From: Samuels, Angela
Sent: 16 April 2021 09:21
To: Rob Smith
Cc: James Cox
Subject: Phase 13 Clarifications

CONSTRUCTION METHOD STATEMENT (NYMNP 94 - PHASE 13) (CMS)

40-SMP-WS-7100-PA-MS-00012

**NYMNP LETTER DATED 3 FEBRUARY 2021 – ANGLO AMERICAN WOODSMITH
RESPONSE – NYM/2021/0037/CVC WOODSMITH PHASE 13 CONDITIONS DISCHARGE**

Figure 1: Tunnel Segments and Dimensions (3 segments high)

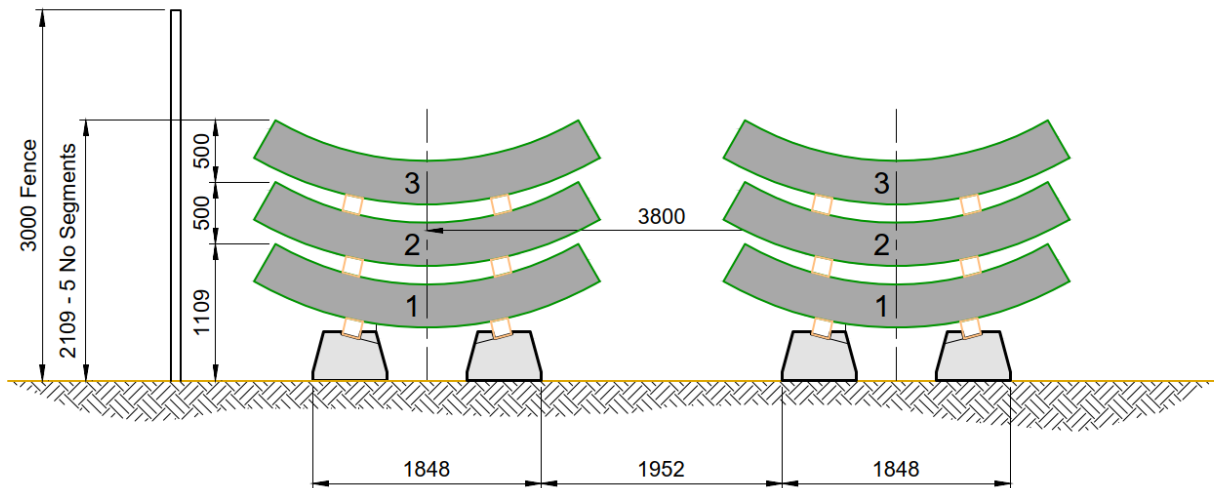
As this area is currently in use for additional temporary car parking, please could you provide more detail on the expected schedule for construction of the temporary pad together with, if relevant, an indication of alternative temporary parking arrangements should that be required.

Please confirm whether it is intended that the concrete pad be removed when it is no longer required for segment storage, the expected duration it is needed and the general methodology for removing it, including expected disposal arrangements.

Is there an expectation of the need for use of any other plant or machinery in this area other than a telehandler and temporary lighting? Does the list of modelled plant include that expected to be used in the eventual removal of the pad?

The temporary laydown area has wooden perimeter fencing on the east, west and south (3m high) which was established in an earlier phase of works to provide screening from the B1416. The perimeter fencing will be extended on the east to provide additional screening in line with the development of the temporary laydown area. The additional fencing will be 3m high. The concrete segments will be stored in stacks of 3, approximately 2.1m high and will not be visible above the perimeter fence (Figure 1).

Segments will be unloaded using a forklift telehandler, exemplified in figure 3. Exact plant will be subject to the configuration of the trailers used to transport the segments. Segments will be stored in stacks of three high, dimensions detailed in Figure 1. The total height, including support, will be approx. 2.1m high and the segments will not be visible above the perimeter fence from the B1416.
